AMENDED BY STAFF 7/23/87
CITY PLANNING COMMISSION

- APPLICATION:**
- A. Negative Declaration
 - B. Special Permit to construct a 69 unit apartment complex in the R-2B-PUD zone.
 - C. Variance to the LPPT PUD Guidelines to reduce 15 foot setback requirements for carports to 7 feet.
 - D. Variance to LPPT PUD Guidelines to reduce 25 foot setback for one-story structures to 15 ft.

PROPOSAL: The applicant is requesting the necessary entitlements to construct a 69 unit apartment complex in the R-2B-PUD zone and the LPPT-PUD (site 10).

P87-287

EXHIBIT A Site Plan

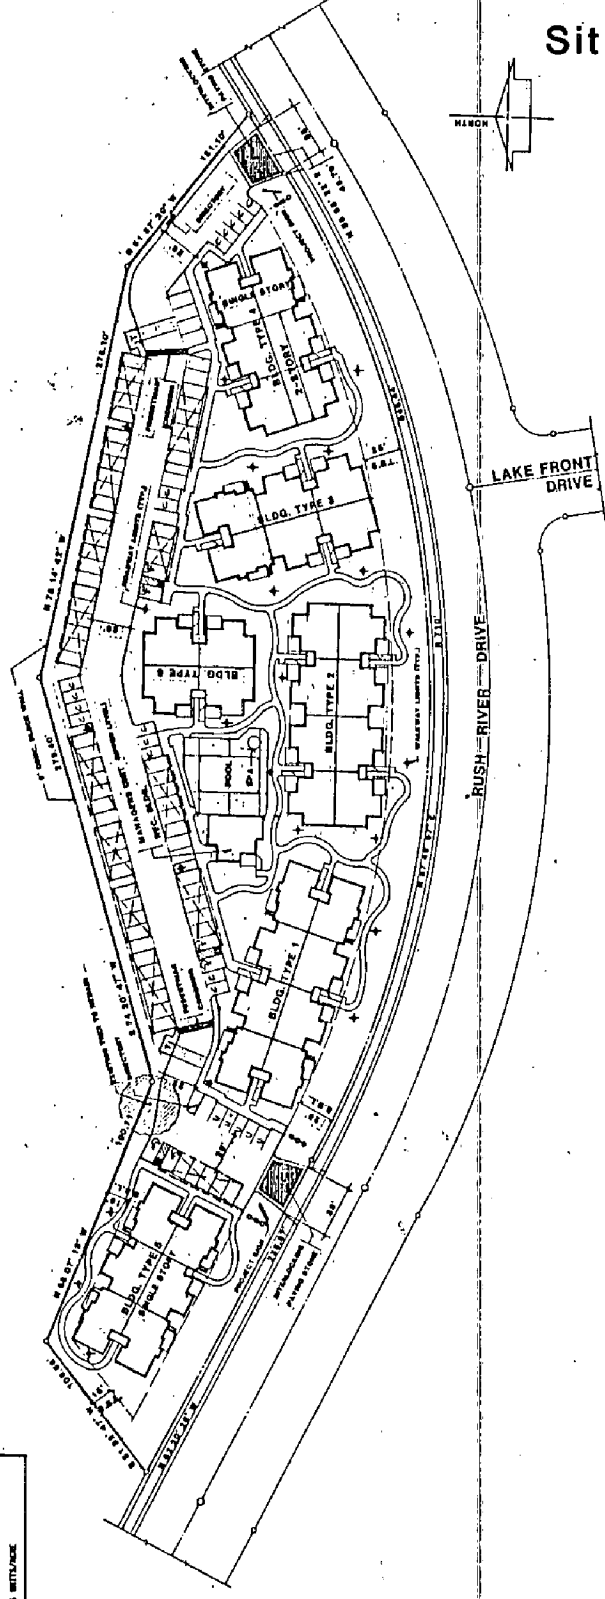
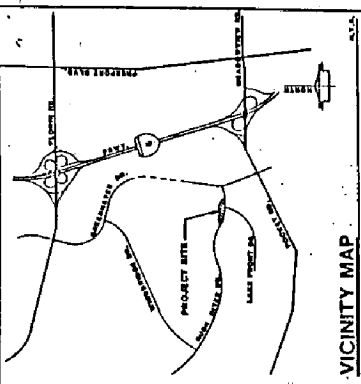
The subject site is irregular in shape and the applicant has designed the site plan so that the covered parking stalls are a minimum of seven feet from the north property line. The LPPT PUD Guidelines indicate that the covered stalls should be a minimum of 15 ft. from adjacent single family residences to act as a noise and visual buffer. The subject site, however, is at a lower grade than the adjacent single family lots and the carport structures will be lower than the lots to the north. The property line on the north runs along the middle of the slope and the applicant has an easement with the present property owner of the single family lots, Citation Homes, to landscape this slope. Planning staff recommends that, in order to minimize the impact of the parking area on future single family residences, the applicant should, if possible, construct the required six foot high masonry wall between the parking lot and the single family homes at the top of the slope and landscape the slope. If this is not possible, staff recommends that the required wall be constructed on the subject site so that it measures six feet from the highest grade of the adjacent single family lots. This height will provide the future residences to the north with an adequate noise and visual buffer. Staff also recommends that the design of the carports be subject to Planning staff review and approval with a decorative feature being incorporated on the top of the carports.

The western portion of the subject site is 109 feet in depth and in order to maintain the required 25 foot landscaped setback along Rush River Drive, a portion of the six unit, one story building proposed for this area is 15 feet away from the north and west property lines. Planning staff recommends that the six foot high masonry wall required for a portion of the north property line be extended along the entire north and west property lines to insure the occupants of these adjacent single family residences their privacy. The wall would not be required in the 25 foot landscaped setback area. The landscape plan indicates a variety of trees and shrubs between the units and the property line which will also act as a noise and visual buffer for the single family residences.

Planning staff noted, while inspecting the subject site, that there is one large oak tree and possibly several small oak trees on the slope that are located on the subject site. All oak trees on the site will be required to be retained and incorporated into the landscape plan.

The submitted site plan indicates several light fixtures along the north property line. These light fixtures need to be screened and oriented away from the adjacent single family lots so they do not produce an annoying glare to adjacent residential uses.

Several of the apartment units have their front doors facing Rush River Drive. Planning staff is concerned that due to the configuration of the buildings and the location of the parking lot at the rear of the site, people will be tempted to park on Rush River Drive and walk across the landscape setback to the apartment units. Staff finds that excess on-street parking would detract from the appearance of the apartment project and produce unnecessary wear-and-tear on the landscaped area. Staff, therefore, recommends that a four foot high decorative wrought iron fence be placed in the 25 foot landscaped setback area in order to discourage unnecessary on-street parking and maintain the appearance of the site.

One hundred and nine (109) parking spaces are indicated on the site plan. Sixty-nine (69) of these spaces are covered. These spaces meet the Zoning Ordinance and PUD parking requirements. Guest parking should be clearly marked and scattered throughout the site. Bicycle parking will need to be indicated on the revised site plan.

- 1. Revised landscape, shading and irrigation plans shall be submitted for Planning Director review and approval prior to issuance of building permits. The revised plans shall indicate either a minimum four foot high decorative wrought iron fence, three foot high decorative wall, or some other decorative barrier which prevents people from walking across the landscape setback, in the 25 foot landscaped setback area. The design of this barrier is subject to Planning Director review and approval. The revised plans shall also indicate heavy landscaping between the single story building and the north and west property lines, the existing trees on the subject site and their species, and shall follow the requirements of the LPPT PUD Guidelines.

- 2. The applicant shall provide a decorative masonry wall between the parking lot and driveway areas adjacent to the north and east property lines. If possible, the applicant shall construct the northern portion of the wall off-site on the adjacent single family lots at the top of the slope and landscape the common slope area of the apartment site and adjacent single family lots. If this is not possible, the applicant shall construct the wall on the subject site so that it measures six feet in height from the highest grade of the adjacent single family lots. Wall design and materials shall be subject to Planning Director review and approval.

- 3. A lighting plan for the project shall be provided and lighting shall be screened and oriented so that it does not produce an annoying glare to adjacent residential uses.

4. The applicant shall provide a six foot high decorative masonry wall along the north and west property lines adjacent to the two existing single family residences. A portion or all of this wall may be waived if the adjacent property owners agree. The wall shall not extend into the 25 foot landscape setback area.

5. Elevations for the carports shall be submitted for Planning Director review and approval prior to issuance of building permits. The carports shall utilize a decorative wood or metal trim fascia and a decorative element shall be incorporated on the top of the carport.

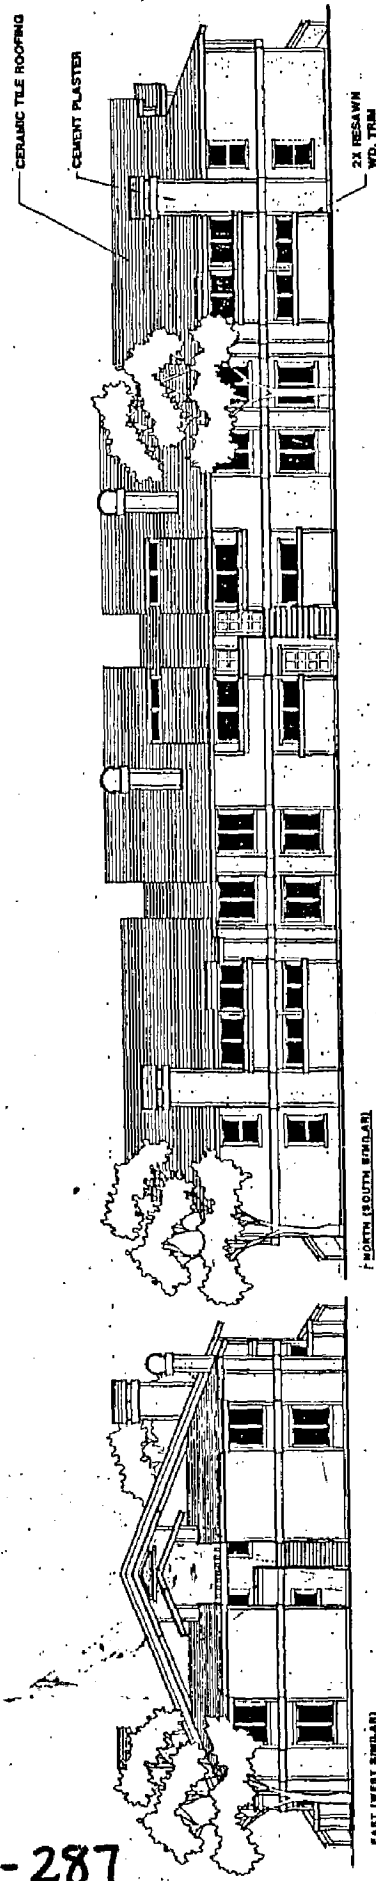
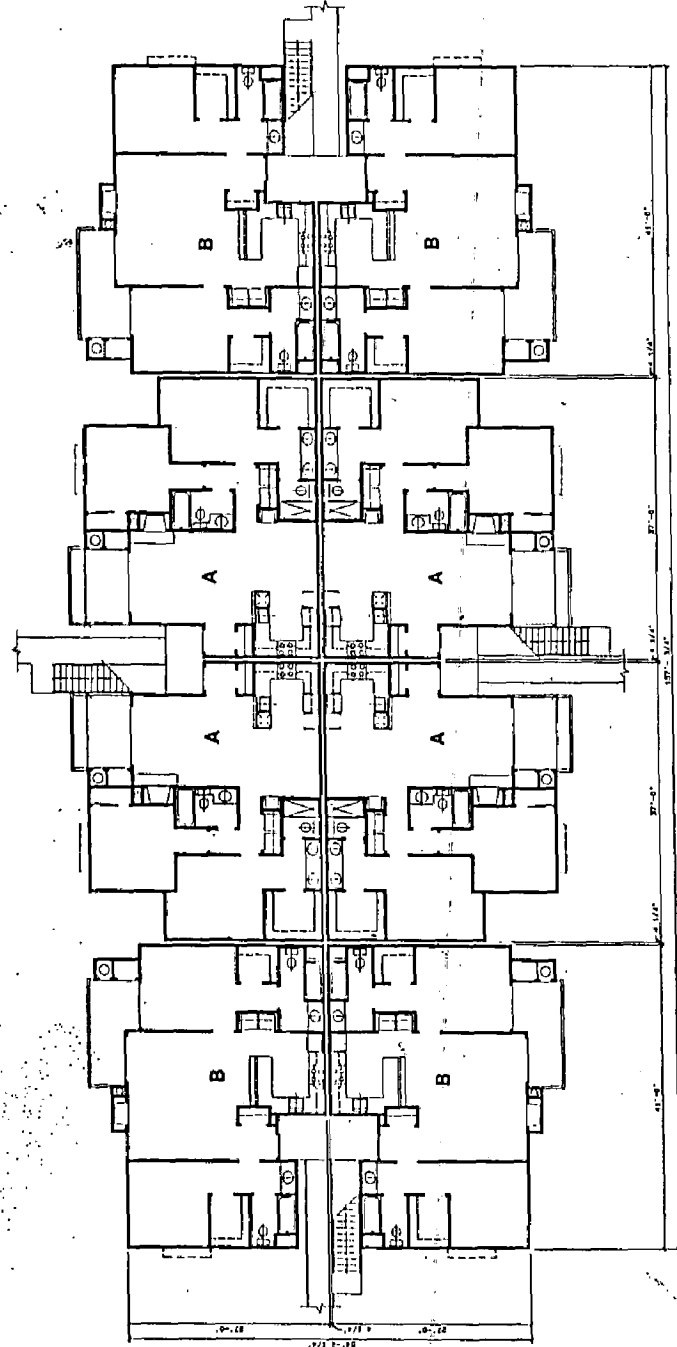
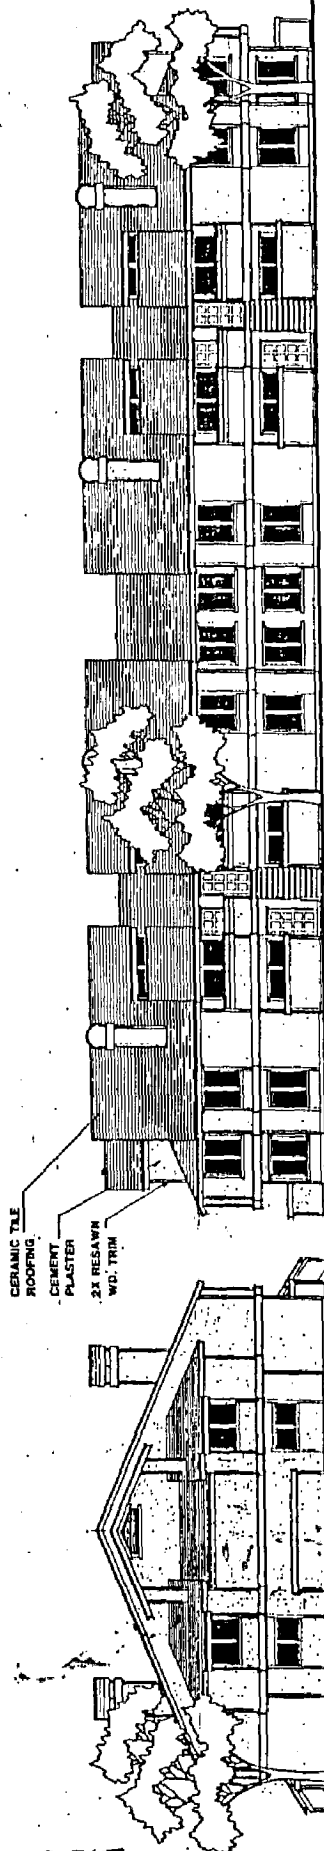
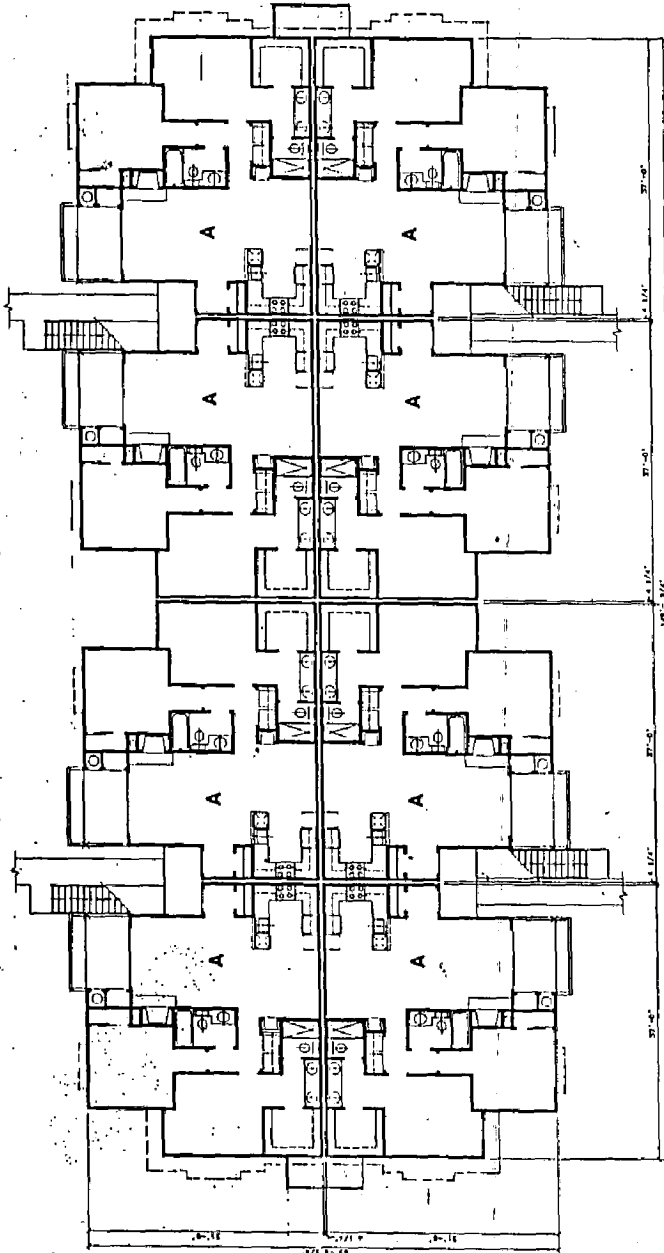
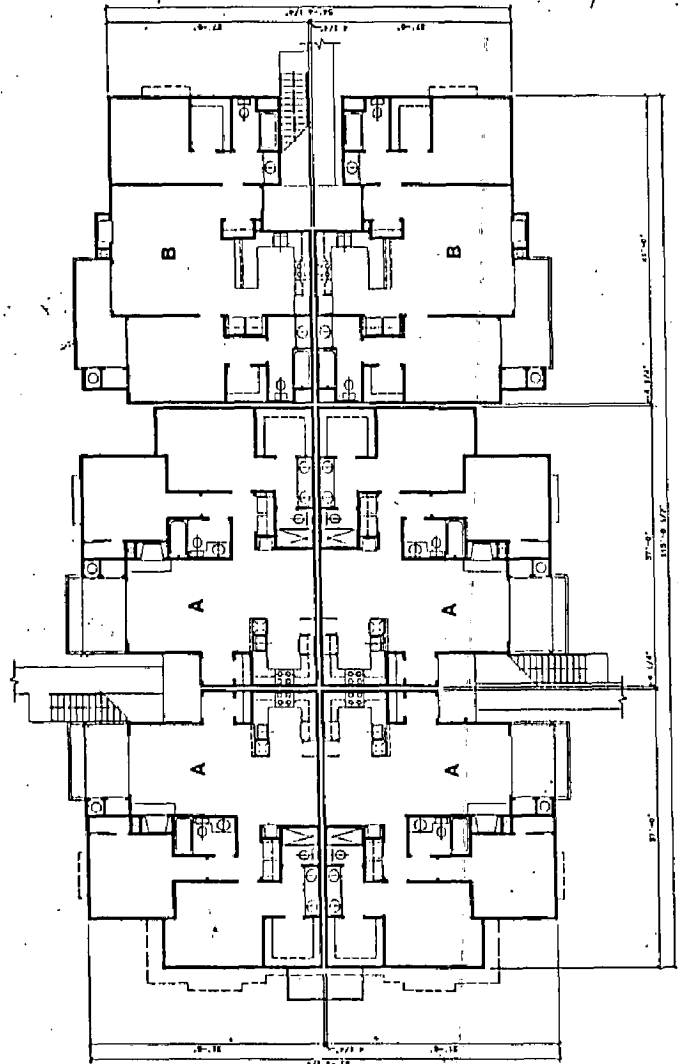
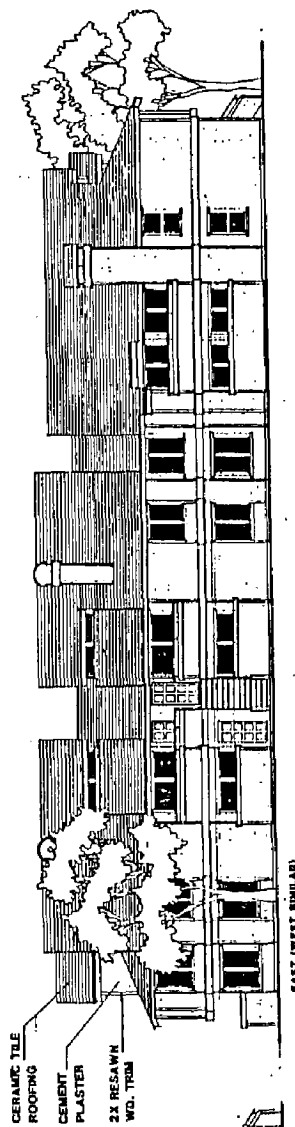
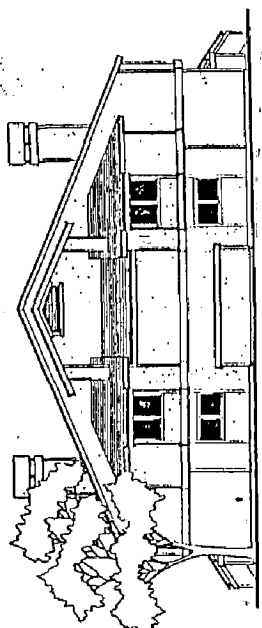
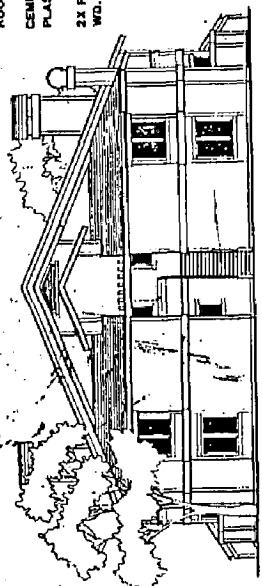
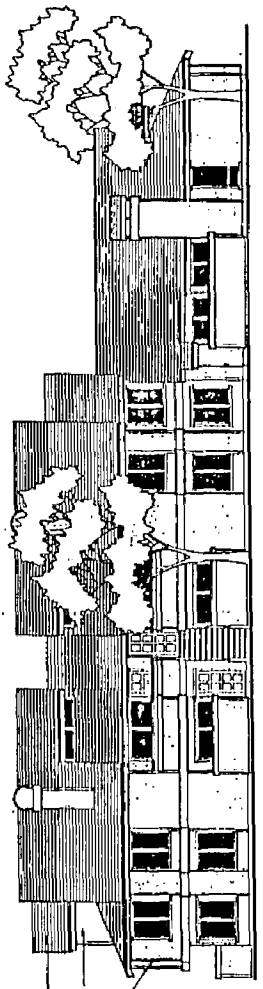
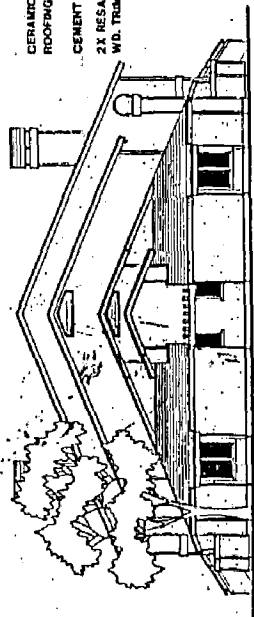
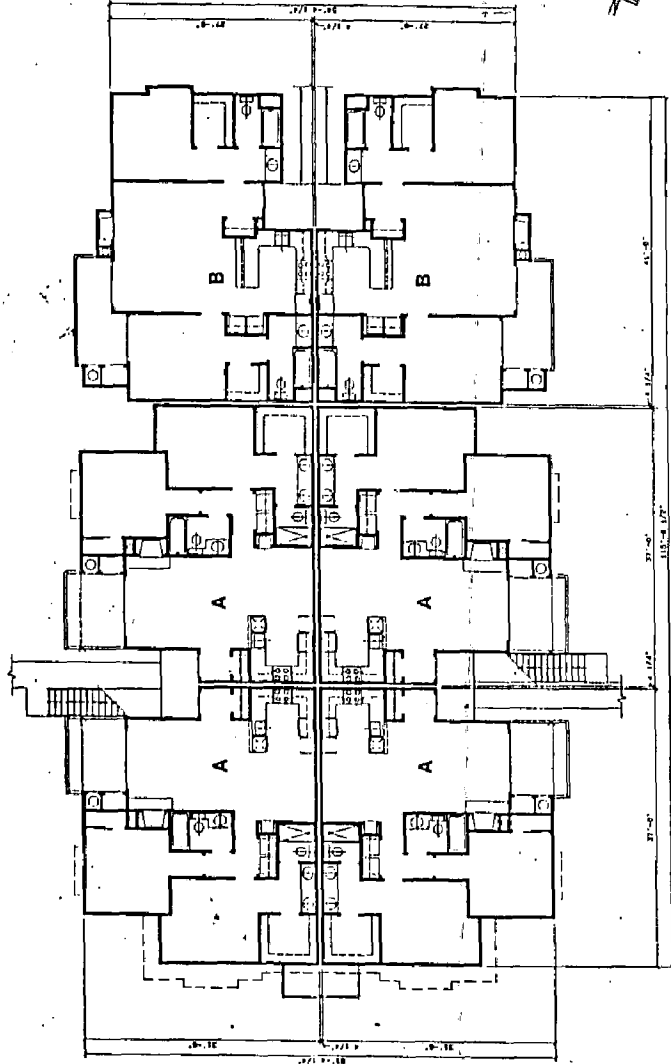
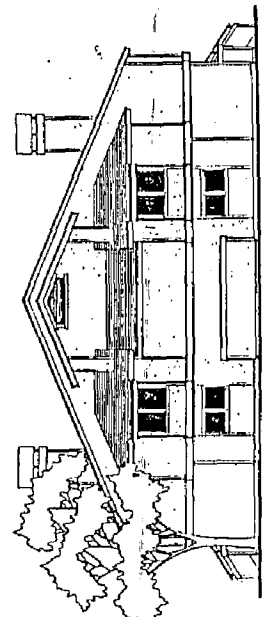
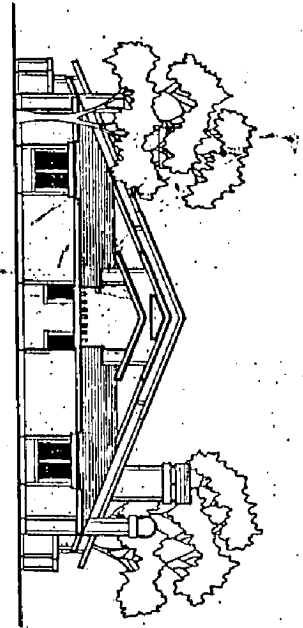
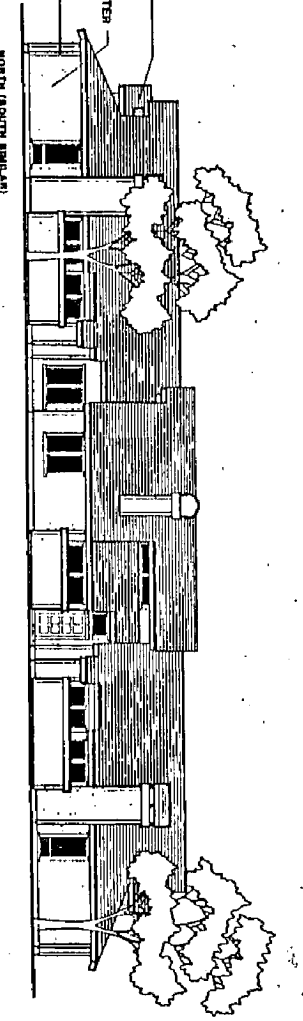
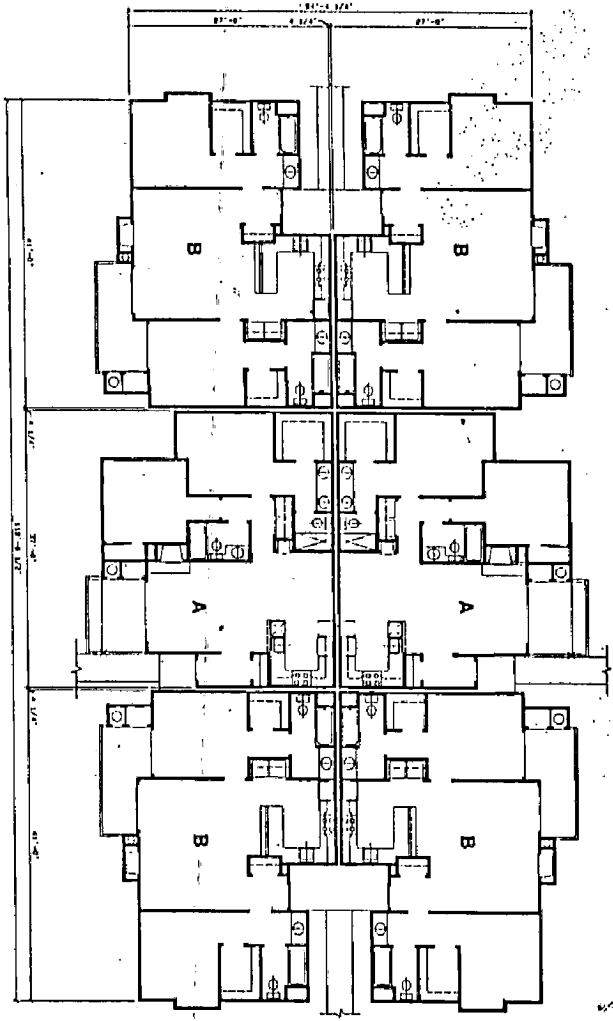
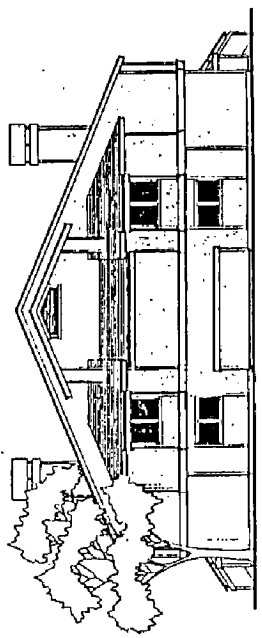
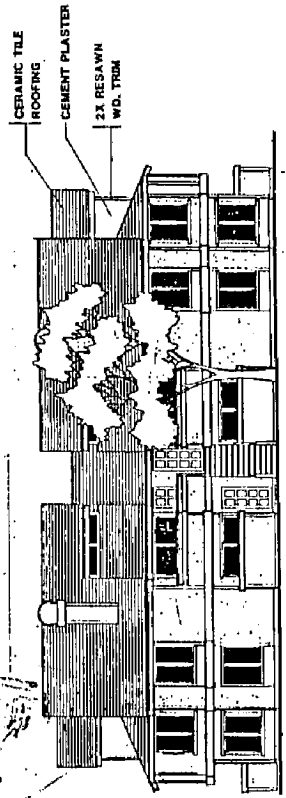
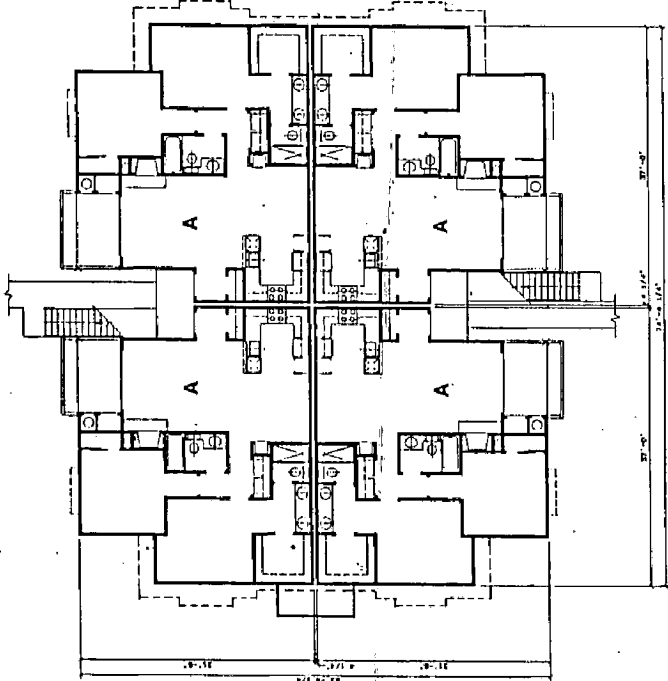
The proposed building materials are a beige cement plaster exterior with a light brown resawn wood trim and a brown ceramic tile roof. The units are located in six buildings and each building type incorporates different design elements. At the request of Planning staff, the applicant provided more windows and building movement to the end elevations. Four of the buildings are two-story; the building on the east side of the site is single story at one end to lessen the impact of the apartments on adjacent single family uses; and the entire six unit building on the western portion of the site is one-story. Two unit types are proposed and all units will have two bedrooms, two bathrooms, fireplaces and washer/dryer hookups. Staff finds the proposed buildings to be attractively designed and compatible with existing and future residential uses in the area.
